APPLICATION NO.	FILING DATE	FIRST NAMED INVENTOR	ATTORNEY DOCKET NO.	CONFIRMATION NO.
10/642,818	08/19/2003	Donald Studer		3092

This is the first office action for application number 10/642,818, Method for Forming a Hanger for a Chain Link Fence, filed on August 19, 2003.

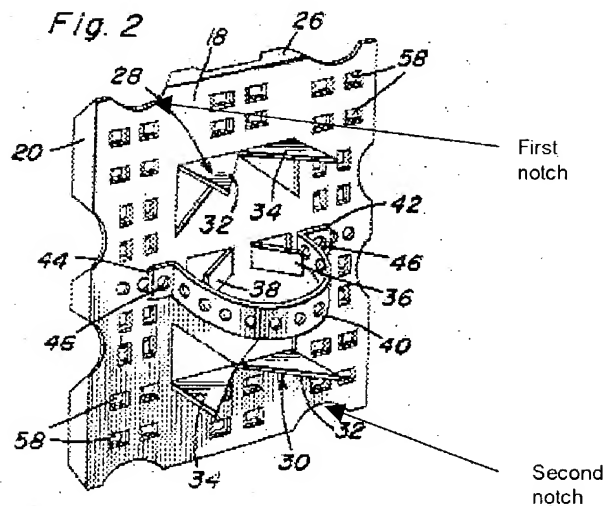
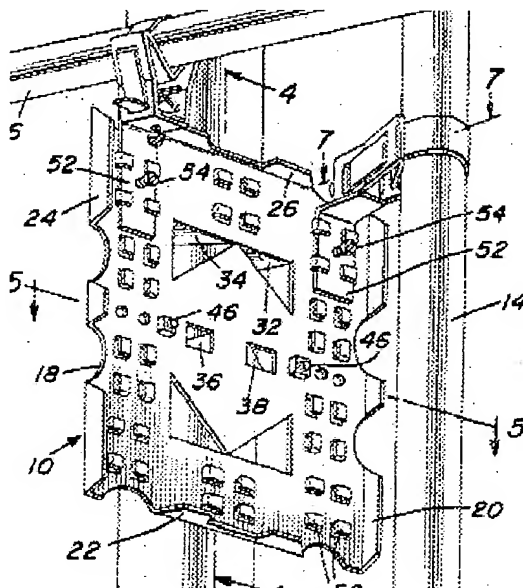
Menser '505 discloses a hook apparatus (above) comprising a first vertically disposed element (18,20) having two oppositely located end portions (right and left side, respectively), a second vertically disposed element (24) integral with the first element and extending from the top one (inherently the "top" depending upon some user's

wherein a flat fold portion (18) connects the first and second elements when the first and second elements are in their folded disposition, the fold portion being disposed perpendicular relative to a vertical reference and perpendicular to both the first and second elements;

wherein the flat fold portion has opposing staggered notches (above) on the anterior side edge of said flat fold portion;

wherein the staggered notches have a first notch (above) centered a distance from the union of the first element and the flat fold portion and second notch (above) centered a distance from the union of the second element and the flat fold portion, both notches having an internal radius;

However, Menser '505 fails to specifically teach the first and second elements to be separated by approximately 1.125 inches in their folded position, the first notch to be centered approximately .431 inches from the union of the first element and the flat fold

portion, the second notch to be centered approximately .431 inches from the union of the second element and the flat fold portion; both notches to have an internal radius of .156 inches, and the elements to have a generally constant width of approximately 2.20 inches. It would have been obvious to one of ordinary skill in the art at the time the invention was made to have constructed the previously mentioned features of any number of various dimensions, including those as specifically recited because doing so is considered a design choice and hence not considered patentable since the applicant has not specifically recited in the originally filed specification why such a dimension is critical to the invention or produces any unexpected result. See *In re Kuhle*, 526 F.2d 553, 188, USPQ 7 (CCPA 1975).
